Response to the Reviewers' Comments

The authors would like to thank the reviewers for the precious comments and suggestions on the technical contents and presentation of our manuscript "Runtime Power Management of Battery Electric Vehicles for Extended Range with Consideration of Driving Time," submitted to IEEE Transactions on Very Large Scale Integration (TVLSI.) This revised manuscript has been greatly improved thanks to the reviewers' invaluable advices. We have revised the manuscript faithfully following the reviewers's comments. We include the newly added or significantly modified parts in the revised version of the paper also in Response to Reviewers. We highlight the important technical content changes and set those parts in a red color in the revised paper.

Fig. 1: (a) Range-speed experimental data for Chevrolet Bolt [36] and (b) comparison with simulation results of the proposed EV power model.

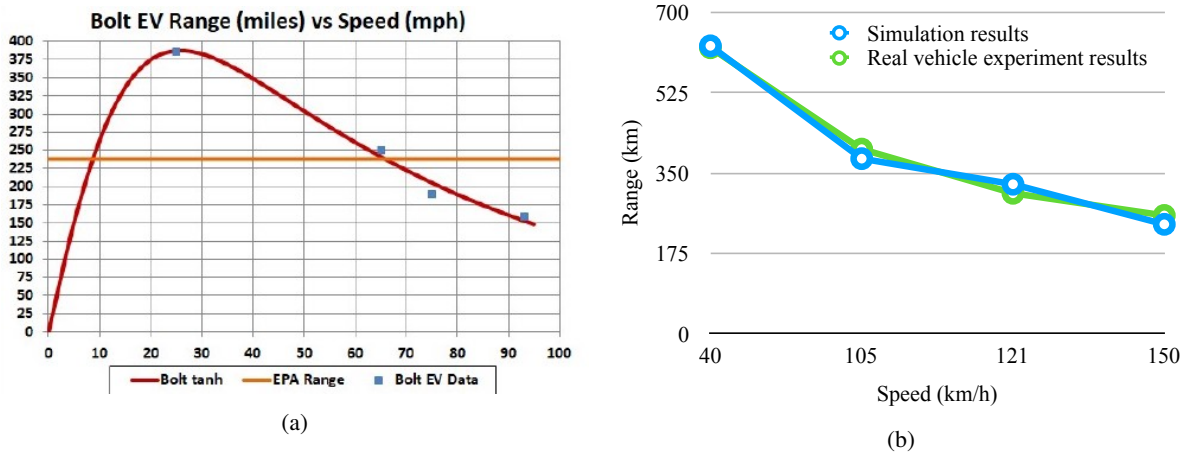
R1-C2 It is not clear how to validate the power model of EV. As the author mentions that accuracy of power model is quite important, it is good to see the power model in this paper can be validated by some real measurement results.

R2-C1 The paper claims that the proposed BEV power model is more accurate than those in the literature. While the results in Section V demonstrate the benefits of the proposed model and in some way indirectly show its accuracy, it would be good to have a direct comparison of model accuracy between the proposed model and those in literature, e.g., based on simulations as in Fig. 1.

Here goes how we extracted correct coefficients of the EV power equation. We use a vehicle simulator that supports EV as well, ADVISOR, to extract the coefficients of new vehicles starting from known vehicle specifications such as the aerodynamic resistance, rolling resistance, curb weight, and so on. Such data is often published in the users' manual, website and so forth. We further use the vehicle performance data such as the top speed, maximum acceleration, and so on, which are also available on the manuals and website. We iteratively run ADVISOR and derive the model coefficients so that all the known values match among each other. We evaluate the model accuracy with the range-speed real vehicle experiments as shown in Fig. 1(a), which has been published by [32], [33], [34], [35], [36]. We further refine the coefficients until all the available data values match well. Finally, the derived EV power model well matches with the range-speed experimental data as shown in Fig. 1(b) as well as the top speed and maximum acceleration, setting the aerodynamic resistance, rolling resistance, curb weight, etc. with the known (fact) values. The errors of the range-speed simulation is merely 1.4%, the time to approach 60 mph at departure is 7.8%, and the top speed is 3.0%, respectively. We revised the manuscript adding the following paragraph with a new figure in Section III-A on page 3 and 4.

We use ADVISOR to extract the model coefficients of new vehicles starting from known vehicle specifications such as the aerodynamic resistance, rolling resistance, curb weight, and so on. Such data is often published in the users' manual, website and so forth. We further use the vehicle performance data such as the top speed, maximum acceleration, and so on, which are also available on the manuals and website. We iteratively run ADVISOR and derive the model coefficients so that all the known values match among each other. We evaluate the model accuracy with the range-speed real vehicle experiments as shown in Fig. 1(a) [32], [33], [34], [35], [36]. We further refine the coefficients until all the available data values match well. Finally, the derived EV power model well matches with the range-speed experimental data as shown in Fig. 1(b) as well as the top speed and maximum acceleration setting the aerodynamic resistance, rolling resistance, curb weight, etc. with the known values. The errors of the range- speed simulation is merely 1.4%, the time to approach 60 mph at departure is 7.8%, and the top speed is 3.0%, respectively. The model coefficient extraction result shows as in Fig. 2. The normalized root-mean-square deviation is 5.1%. Table I summarizes the model coefficients of (5) for Chevrolet Bolt.

R2-A1 We appreciate the reviewers in that we can more efficiently deliver our technical contributions with a clearer evidence from the valuable comment. Reviewer 1 also questioned the BEV power model validation, and we added this contents in Section III-A on Page 3. The proposed EV power model well matches with the range-speed measurement data provided by [32], [33], [34], [35], [36]. Please find the detailed answer with R1-A2: the answer (response) to the second comment of Reviewer 1.

Fig. 12: Comparison of *EDP* for various energy-aware-velocity planning methods.

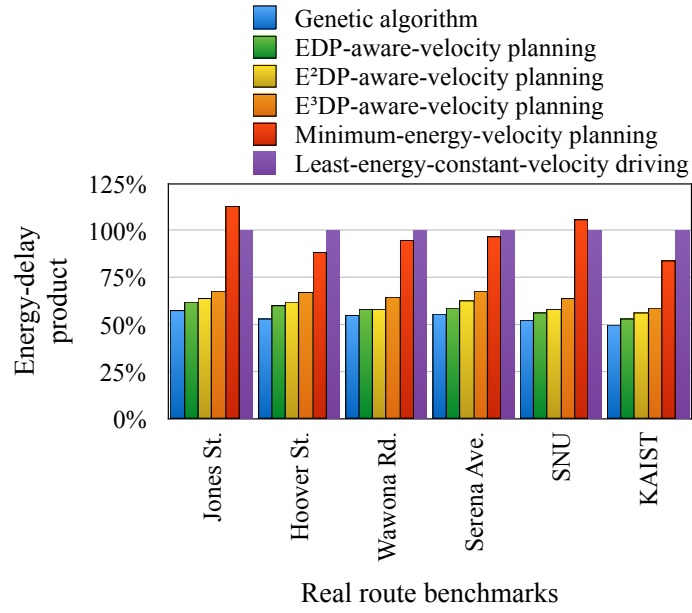
R1-C3 The optimality of the proposed scheduling algorithm is unclear. The author should add several paragraphs to discuss this topic. It is also to see the comparison baseline is well accepted to show the advantage of the proposed algorithm.

R2-C5 The baseline for comparison is the least-energy-constant-velocity scheme. As the optimal velocity significantly depends on road slope, such scheme is obviously sub-optimal. It would be interesting to see how the proposed method compares with a simple extension of least-energy-constant-velocity, where a constant velocity is calculated for each segment with the same slope.

Fig. 12 shows EDP of the least-energy-constant-velocity driving, the velocity planning with EDP , E^2DP and E^3DP as a metric on various road benchmarks and the minimum-EDP-velocity planning with GA. The proposed velocity planning results in up to 47% improvements of EDP compared with the least-energy-constant-velocity driving. The improvements occur especially when the slope of the uphill is steep. The driving velocity on a flat road is faster than that of the least-energy-constant-velocity driving at the expense of relatively little energy to save driving time. Then, the velocity decreases when climbing the following uphill to spend less motor torque, which saves more energy.

In addition, the proposed EDP-aware-velocity planning is merely 7.8% higher than the true EDP-minimum-velocity planning on average. Through this results, we confirm that the results of the proposed heuristics are close enough to the true optimal solutions.

We also updated Fig. 12:

Fig. 13: Histogram of (a) velocity and (b) acceleration for various energy-aware-velocity planning methods.

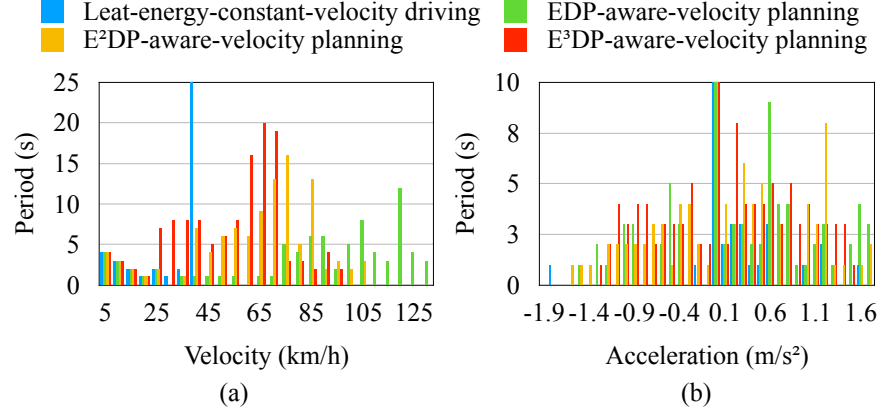
R2-C2 It would be good to have more discussion on the assumptions of the approach and the experiments, e.g., how much can the velocity be changed in practical scenarios without impeding traffic and causing unsafe situations (also depending on the road conditions and whether it is urban or rural environment I suppose). Currently, there only seems to be one constraint on not slower than 10 km/h.

R3-C2 Three different energy-delay product metrics are given in the paper. Can you recommend which one would be the best practical scenarios?

We assume that the EV should not drive too slow to avoid bothering traffic with the minimum speed of a 25 km/h. Even with the minimum speed constraint as lower than 25 km/h, we exhibit the same amount of gains with the proposed methods. After carefully analyzing the acceleration histogram, we newly enforce the minimum acceleration not lower than 0.4 m/s^2 when the EV starts from a stop sign or a traffic light until the velocity reaches to 25 km/h not too bother traffic flow. If the EV accelerates at a 0.4 m/s^2 , it would take 15

seconds to reach a 25 km/h speed. The maximum acceleration is limited by the motor torque: a 4.7 m/s^2 on a flat road. However, such a fast acceleration negatively affects to the power consumption as well as passenger comfortness. We limit the maximum acceleration to 1.7 m/s^2 as shown in Fig. 13(b), which is the same as the maximum acceleration of compact cars designed to be used primarily used in urban areas (15 seconds of 0 to 100 km/h time).

We quantize the velocity and acceleration values and make a histogram as shown in Fig. 14 (Please refer R2-A2). For the EDP -aware-velocity planning, it is used when the deadline is the most important concern. Therefore, it is guided to drive at a speed of 75 to 130 km/h mainly regardless of the road slope. On the other hand, the E^2DP - and E^3DP -aware-velocity planning methods are used when the remaining battery state of charge is more concerned than the deadline. It is guided to drive at an energy-efficient speed along a road slope. Particularly, the E^3DP -aware-velocity planning method is used when the state of charge is more concerned, and the driver should find the nearby charging station. It is guided to decelerate to 25-40 km/h when climbing hills to further reduce energy consumption.

Fig. 9: Benchmark altitude.

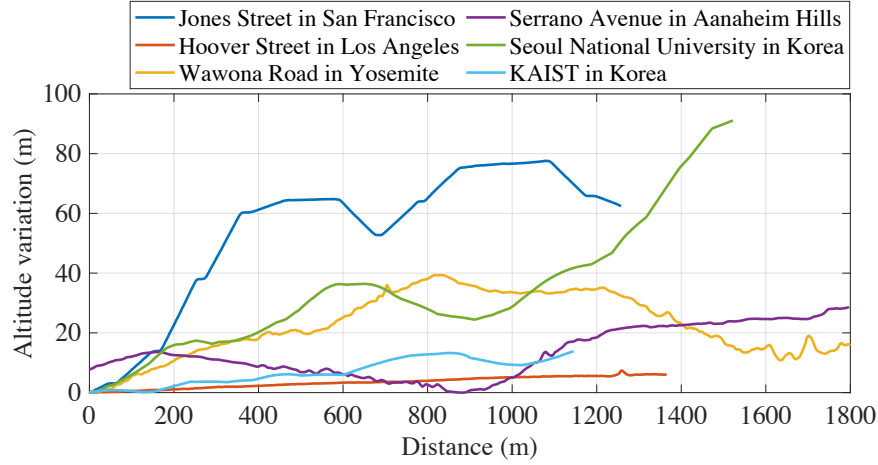
R2-C3 Related to the last point, it would be good to have more discussion on the road benchmarks, e.g., how they are generated and how representative they are. The optimization results significantly depend on road slope. It would be good to use a variety of real road segments for testing.

R2-A3 We appreciate the reviewer’s comment and added six new real routes from various locations in the world. First two routes consists of road segments in cities (San Francisco and Los Angeles, the two representative city landscapes such as hills and flat roads, respectively). The second two routes are road segments in mountain areas (Yosemite and Anaheim Hills in California.) The last two routes are university campus road segments. The details of route data is summarized in Table II and Fig. 9, which visualize the altitudes of the benchmarking routes.
